REnescience Northwich

Appendix G: Drainage Strategy

Appendix G - Addendum

The following paragraphs replace the text provided within paragraphs 4.19 and 4.20 of the Drainage Strategy Report (Appendix 8.A:Drainage Strategy).

Document Number	Revision	Subsity
Figure 8.C	D	S2

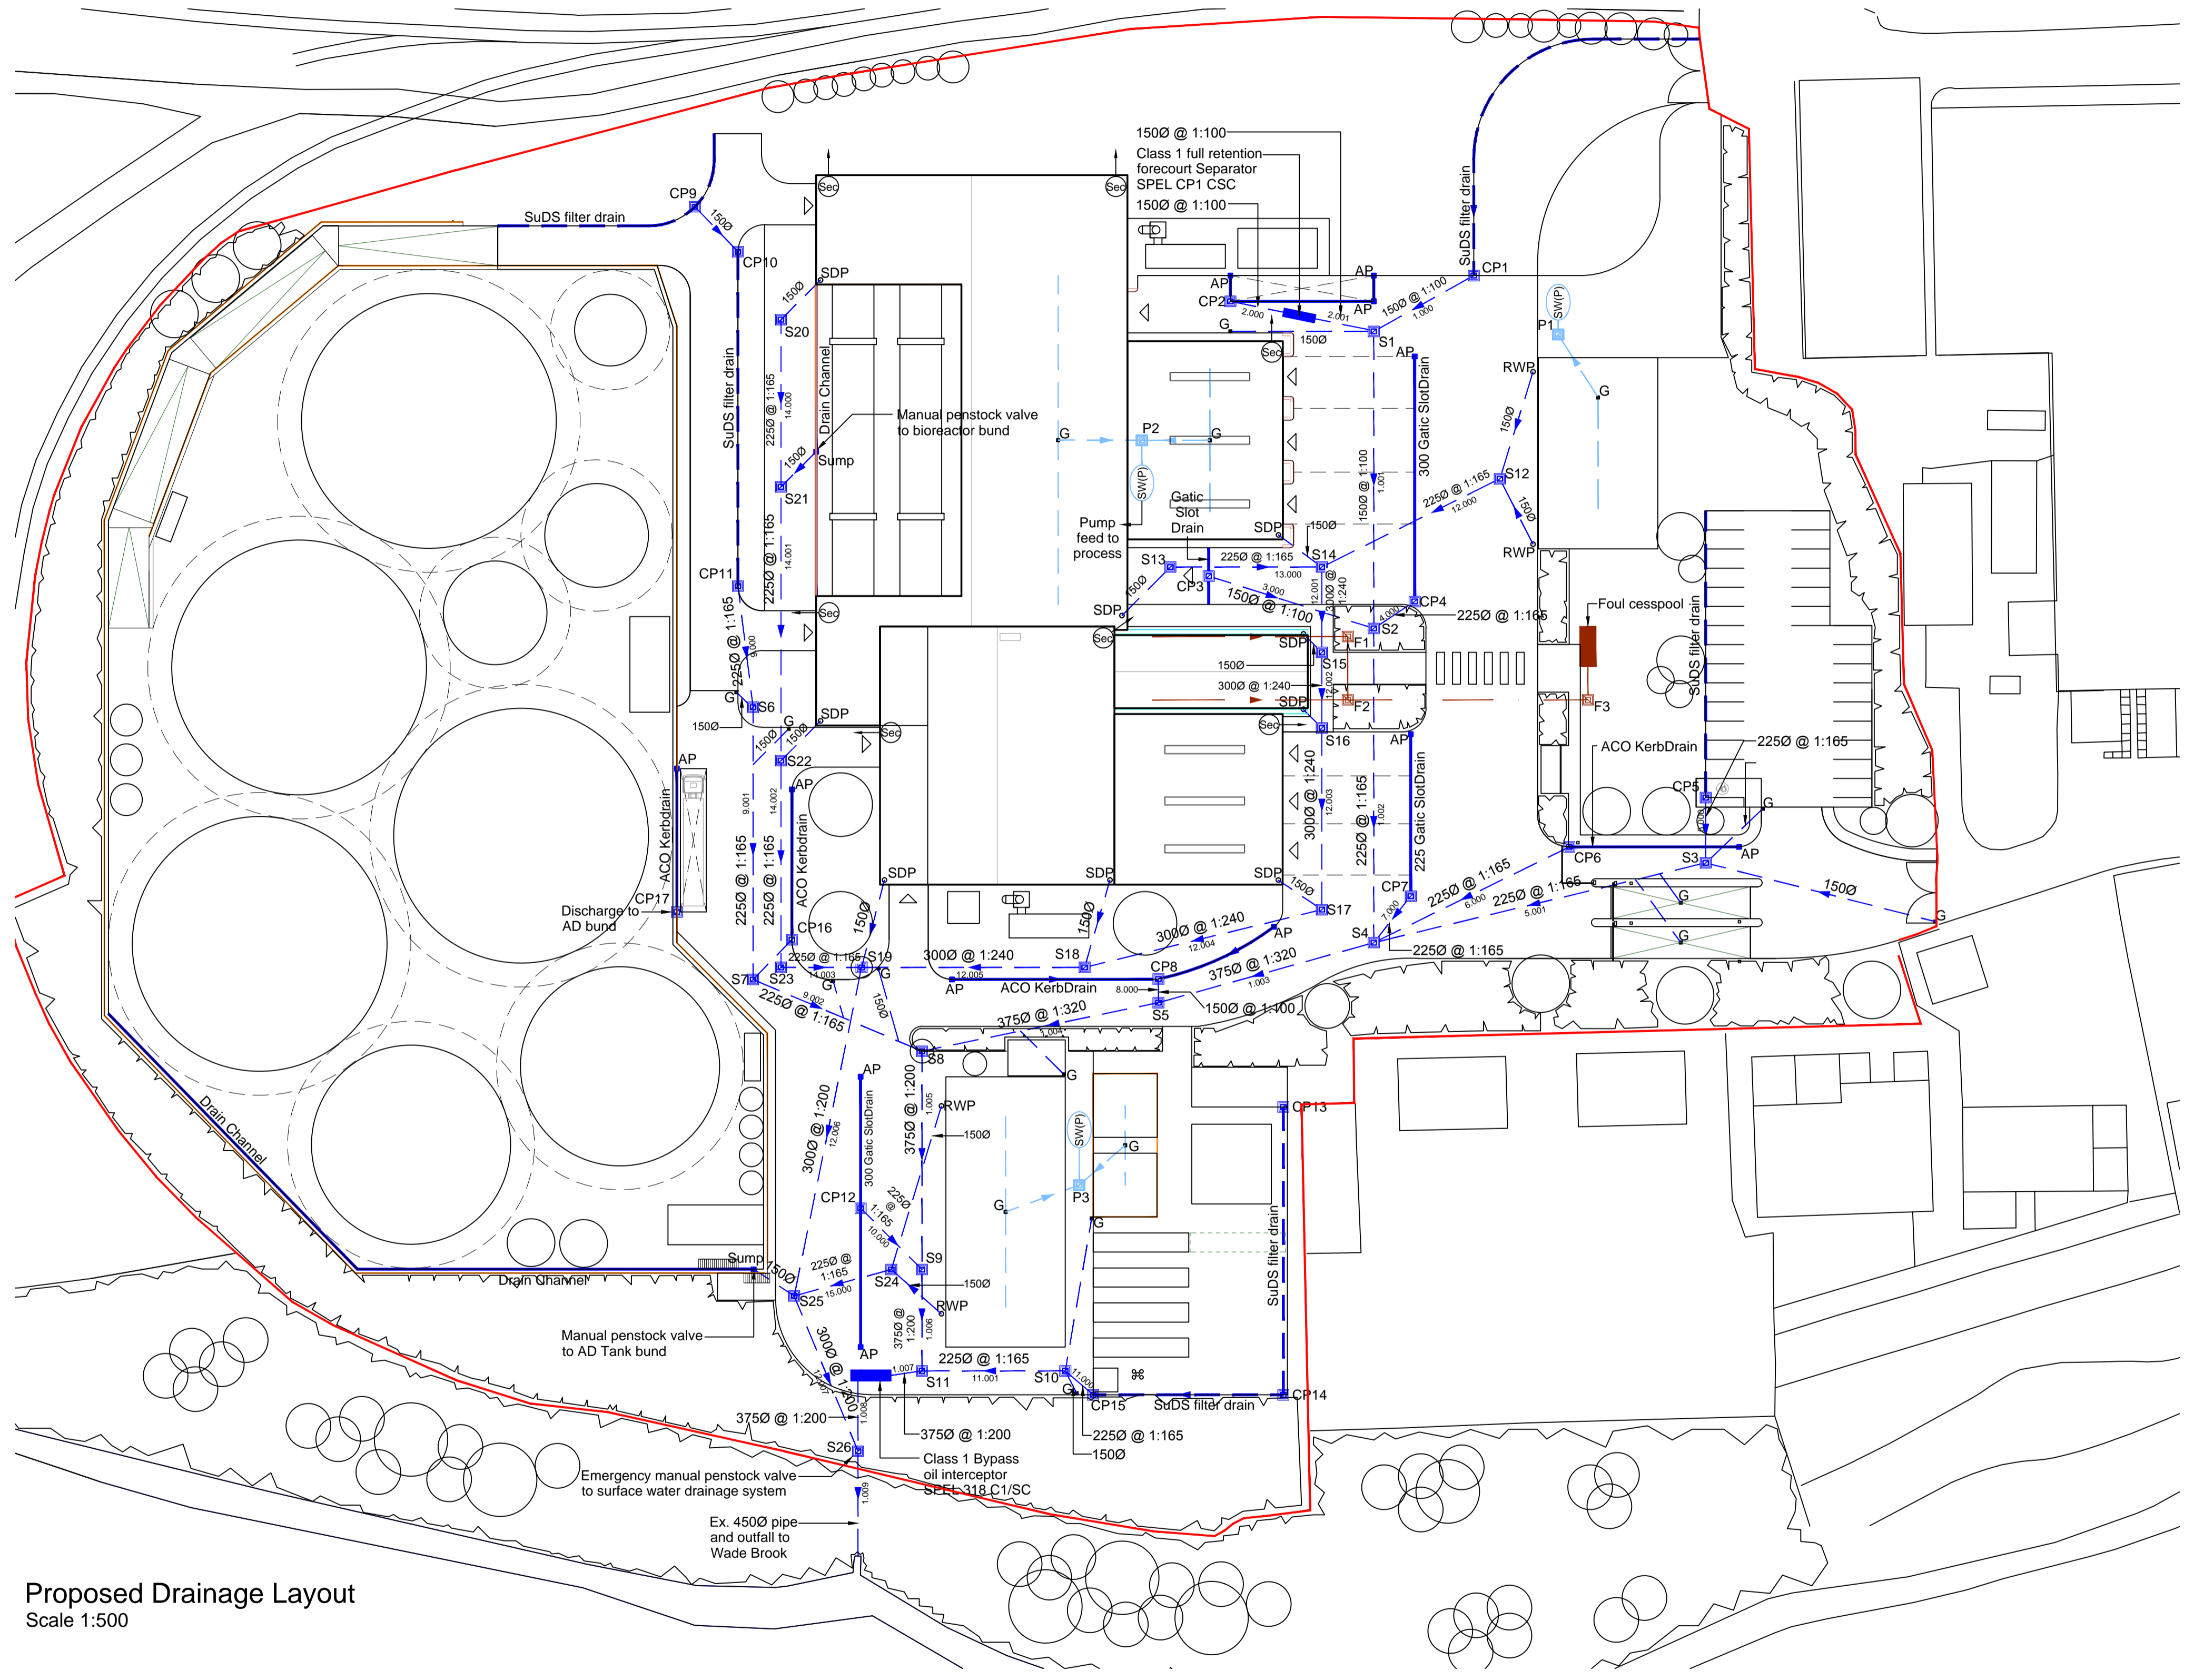
- 4.19 The CLO material storage area will be covered by a formal canopy structure and will have walls on three sides. Roof drainage to this structure will be consistent with the strategy detailed above for other building roofs. Any liquid run-off from the CLO store will be drained to a central drainage channel, which will drain to a below ground holding sump and will be re-used within the process or if not suitable sent for off-site disposal.

- 4.20 RDF/SRF and recycled material will be stored on a concrete slab. Any rainwater or in the event of a leak liquid run-off from the storage area will be drained to a central drainage channel, which will drain to a below ground holding sump. The sump will include level monitoring and alarms to alert the operator before the sump becomes full. The contents of the sump will be monitored for contamination (e.g. pH and conductivity). Where the water is free from contamination the sump will be sent to the process water tank or manually discharged to Wade Brook. If contamination is identified the water will either be returned to the process water tank or off-site disposal arranged should the contents be unsuitable for process use.
